August 23, 2022

SUBJECT: Dipsea Ranch (Weissman) Land Division (Tentative Map) and Mitigated Negative Declaration Amendment (P3546)

Fig. 46

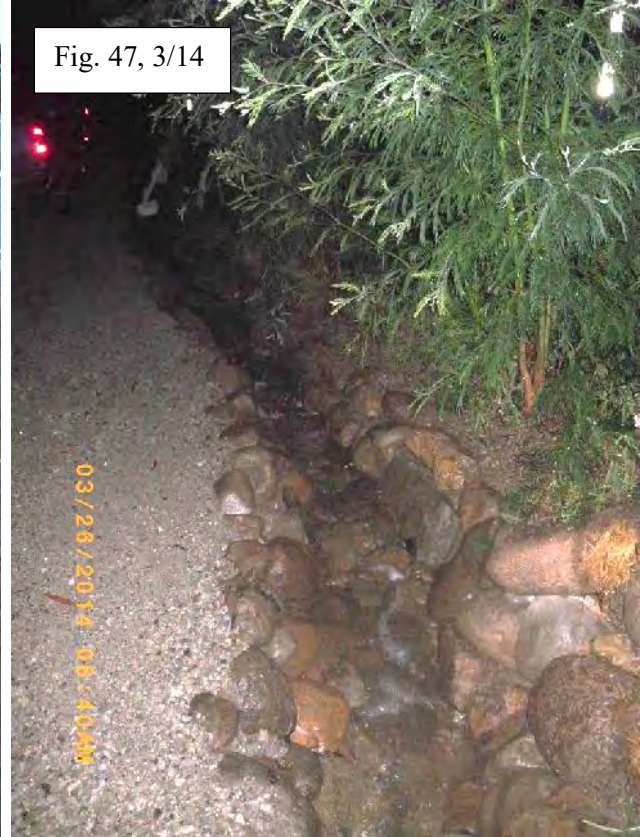
Figures 46, 37, and 48 were taken by an unknown photographer. The images were provided by the Marin Watershed Alliance. The date of Figure 6 is unknown yet likely predates the other two taken on 3/14. The photos document conditions of the road ditch about 8 years ago and serve as a good comparison to current conditions. Now, the rock-lined swale has deposited sediment and is bypassed by an adjacent channel, shown in Figure 49.

Fig. 51

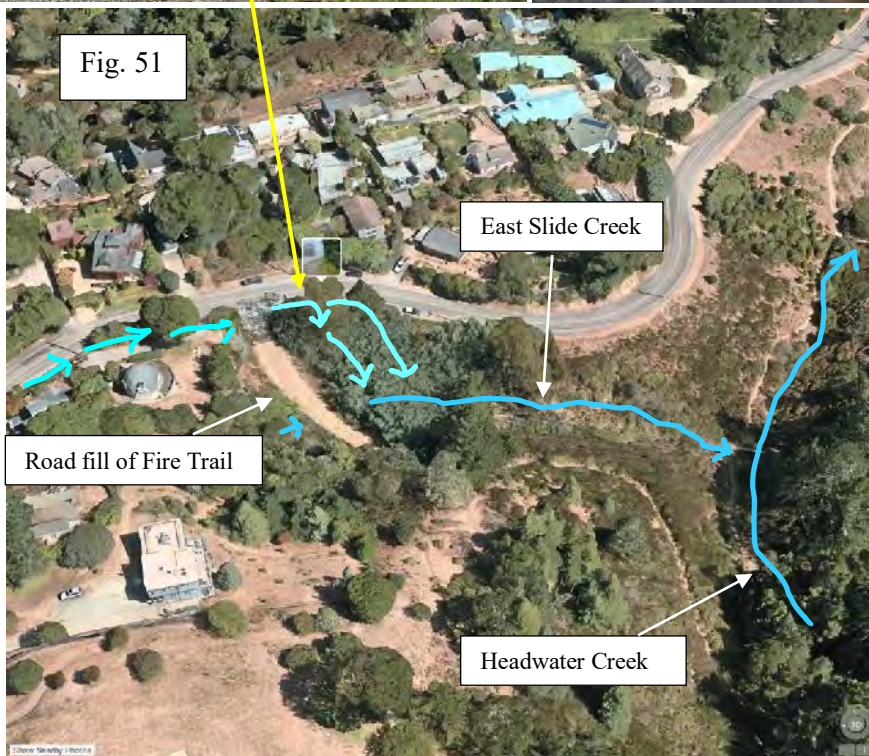
Figure 49 shows current conditions of the same location of Figure 50. The location site is shown by the yellow arrows in Figure 51. Figure 50 photo provided by Marin Watershed Alliance, was taken 5/2014. It looks downhill from the Fire Trail driveway at urban runoff flowing into a gully leading to East Slide Creek. Figure 49 shows the same cyclone fence (covered with ivy) in Figure 48. Figure 50 exemplifies the amount of water that can be produced by impervious surfaces. Flow from every impervious surface creates cumulative impacts of sediment supply from streambed and bank erosion of tributaries and to Redwood Creek's fish habitat and increased flood frequency.

Figure 6. Wetlands Road Encroachment

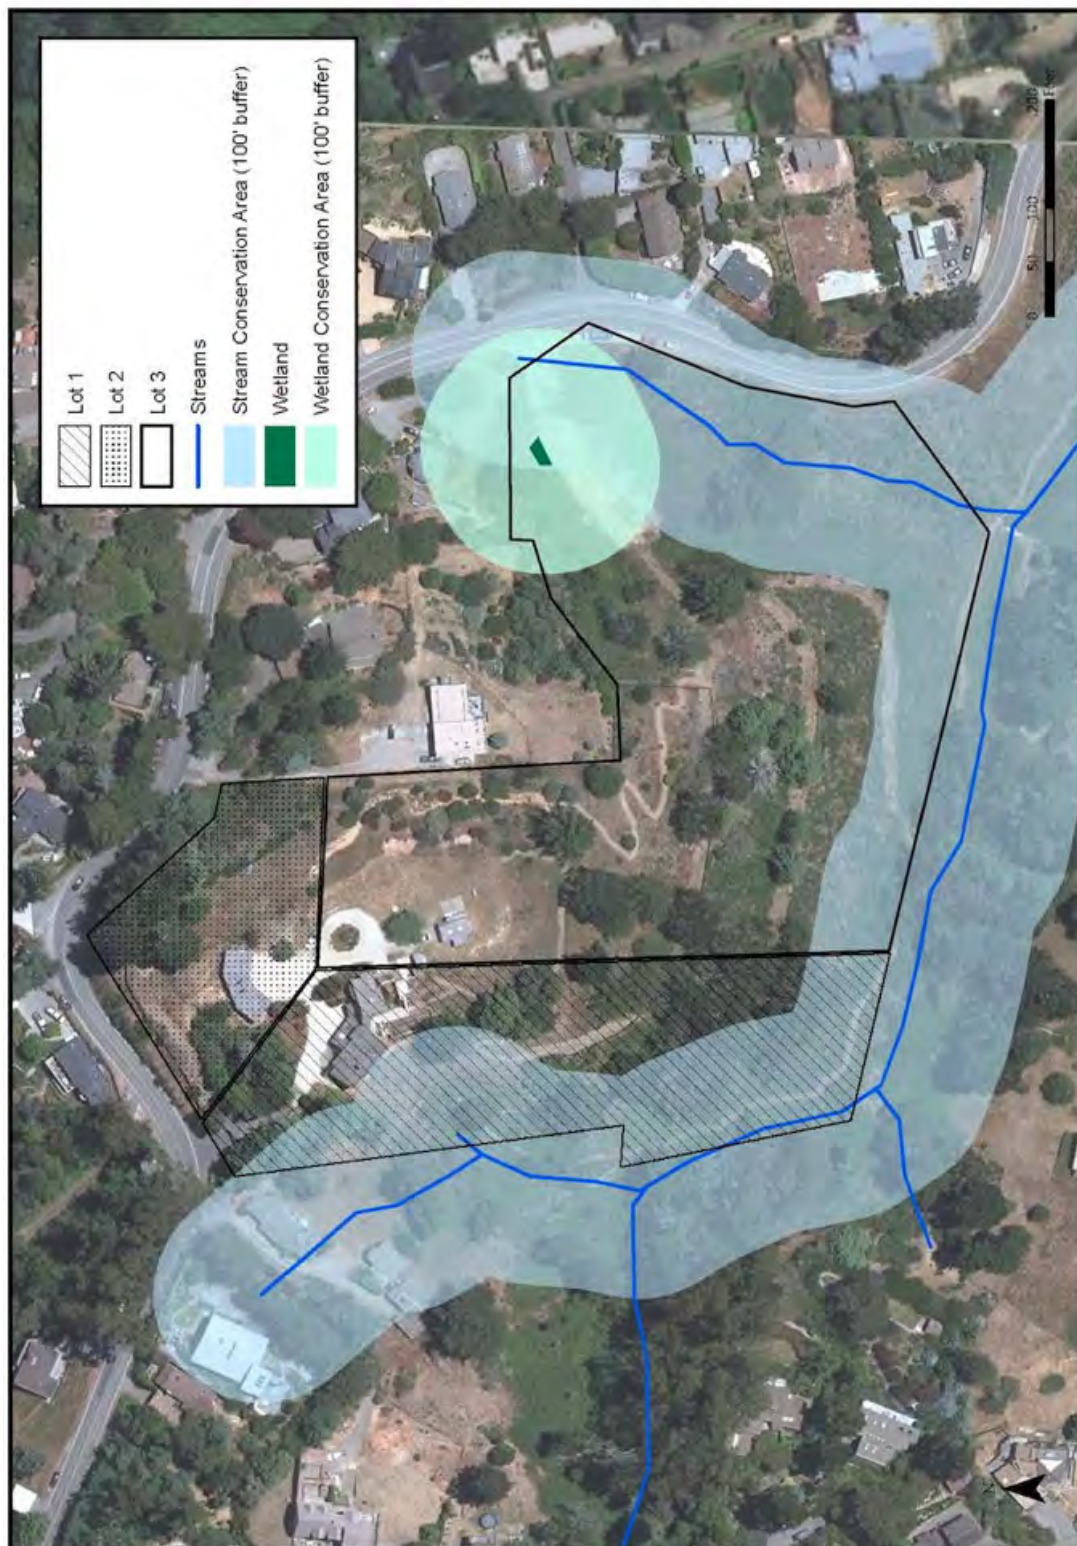
have the potential to buildup hydrostatic pressure and lead to separation of the fill from the native grade, potentially causing failure. Inadequate stormwater management on steep slopes and on new cut and fill will have an adverse impact on the habitat. Loss of groundwater infiltration with cisterns, pipes and bioswales impacts year-round base flows potentially dangerous for salmon downstream. (Figure 6 and 8)

Figure 8. Notes: Submitted May 1, 2018, Herzog Geotechnical Engineering. First boring is on Fire Road above Herzog text/ Registered sloughing and instability.

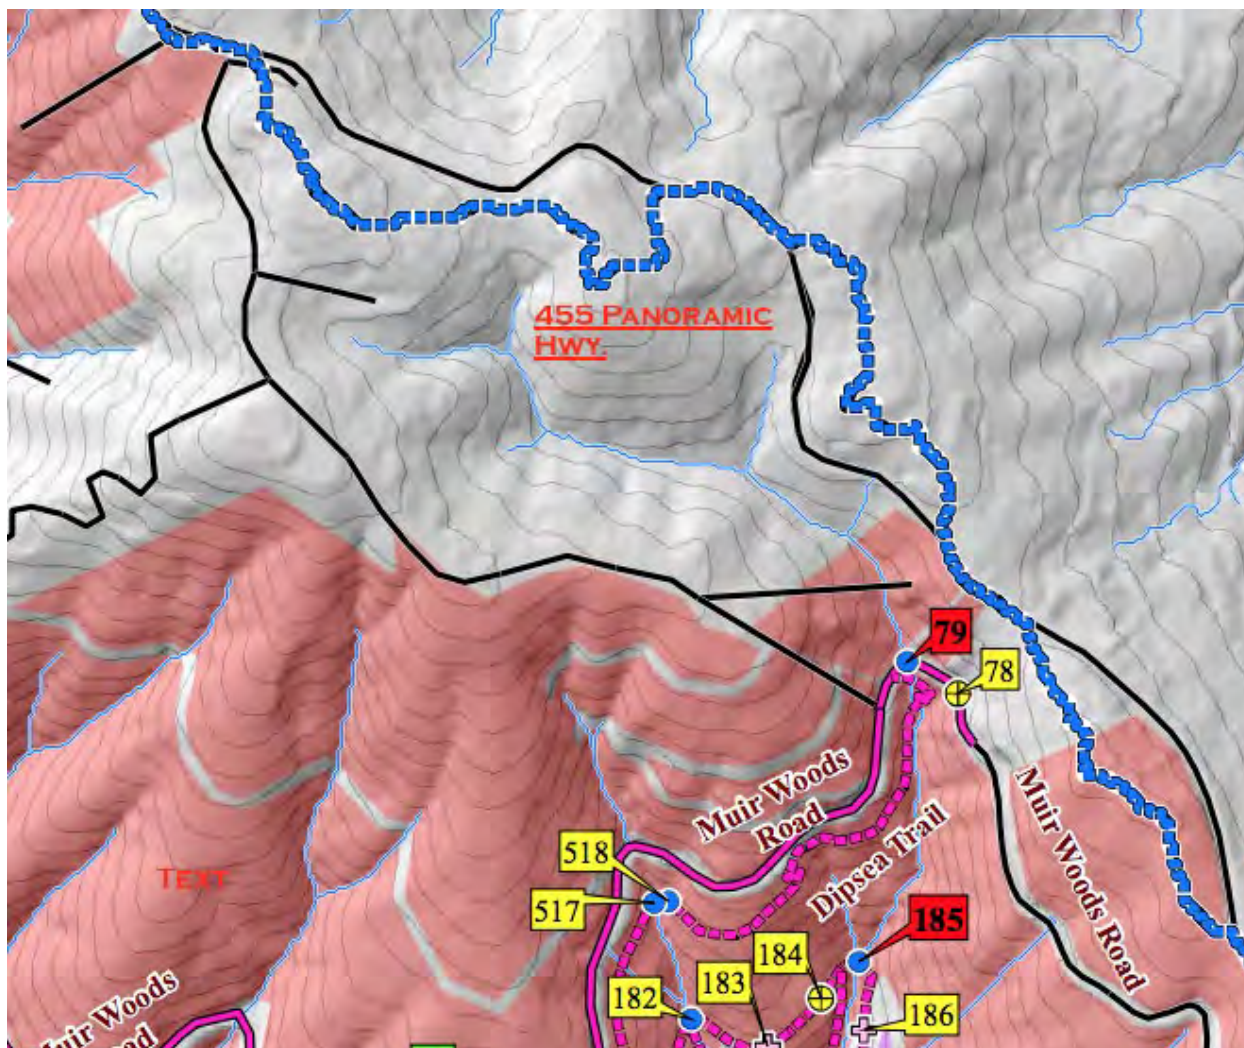
The proposed projects include grading 1,700 cubic yards of soil, augmentation of the ground and soils for septic systems, bioswales, cisterns, foundations, and driveways; all part of and affecting the Stormwater Control Plan (Figure 8). This will impact groundwater infiltration to the surrounding 1400 linear feet of creek year-round base flows, water temperature, erosion and Critical Habitat. (Figure 5) Related to the Stormwater Control Plan, is the potential construction of 12 homes, with dozens more vehicles and trips, that would release the highly toxic quinone transformation product of *N*-(1,3-dimethylbutyl)-*N'*-phenyl-*p*-phenylenediamine (6PPD), a globally ubiquitous tire rubber antioxidant deadly to coho, plus fertilizer and pesticides, all less controllable once the project has been fully implemented.
